HISTORIC AND DESIGN REVIEW COMMISSION

HDRC CASE NO: 2018-256
ADDRESS: 139 E COMMERCE ST
141 E COMMERCE ST
106 RIVERWALK
143 E COMMERCE ST
145 E COMMERCE ST
147 E COMMERCE ST
149 E COMMERCE ST
151 E COMMERCE ST
LEGAL DESCRIPTION: NCB 106 BLK LOT 27
NCB 106 BLK LOT 28
NCB 106 BLK LOT 29 & 30
NCB 106 BLK LOT 31
ZONING: D, HS, RIO-3
CITY COUNCIL DIST.: 1
LANDMARK: Commercial Building
APPLICANT: Keller Henderson/Keller Henderson Interiors
OWNER: Burgos LP/Uriarte LP
TYPE OF WORK: Demolition with new construction of seventeen story residential tower with retail
APPLICATION RECEIVED: November 16, 2018
60-DAY REVIEW: January 15, 2018
REQUEST:

1. Demolish the structures addressed as 139 and 141 E Commerce. These structures are individually designated historic landmarks; however, they do not feature a common name.
2. Construct a seventeen story, residential structure to feature both street and river level retail space.

Automobile storage

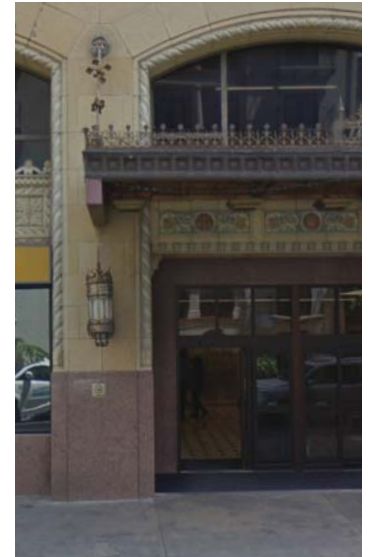
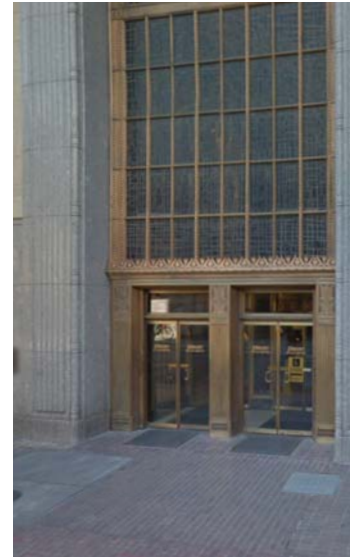
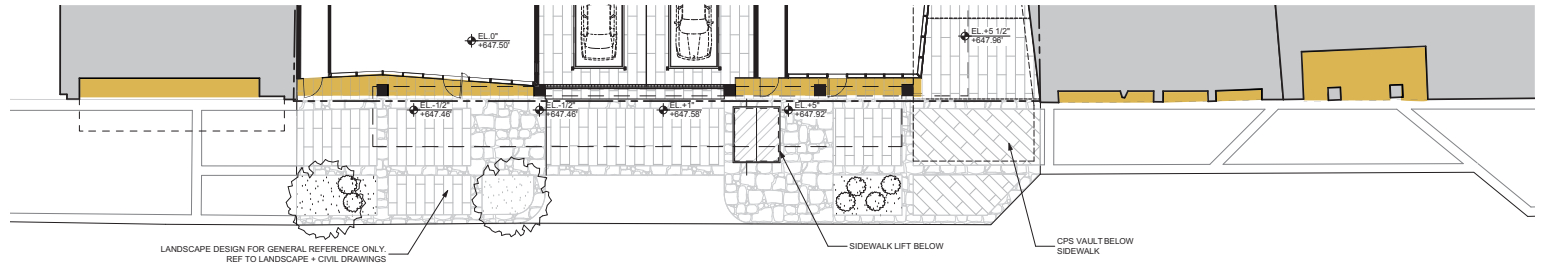
- vi. That the applicant make every attempt to reduce pedestrian conflicts with the proposed automated parking system. The parking load should be reduced by securing off-site parking, and special paving or other visual cues should be implemented. Additional information should be provided to fully understand the operation of the garage and potential queuing on the pedestrian sidewalk. **The applicant has incorporated safety and design elements, including a change in paving to accomplish this.**

In-grade and column mounted pedestrian flashing warning lights
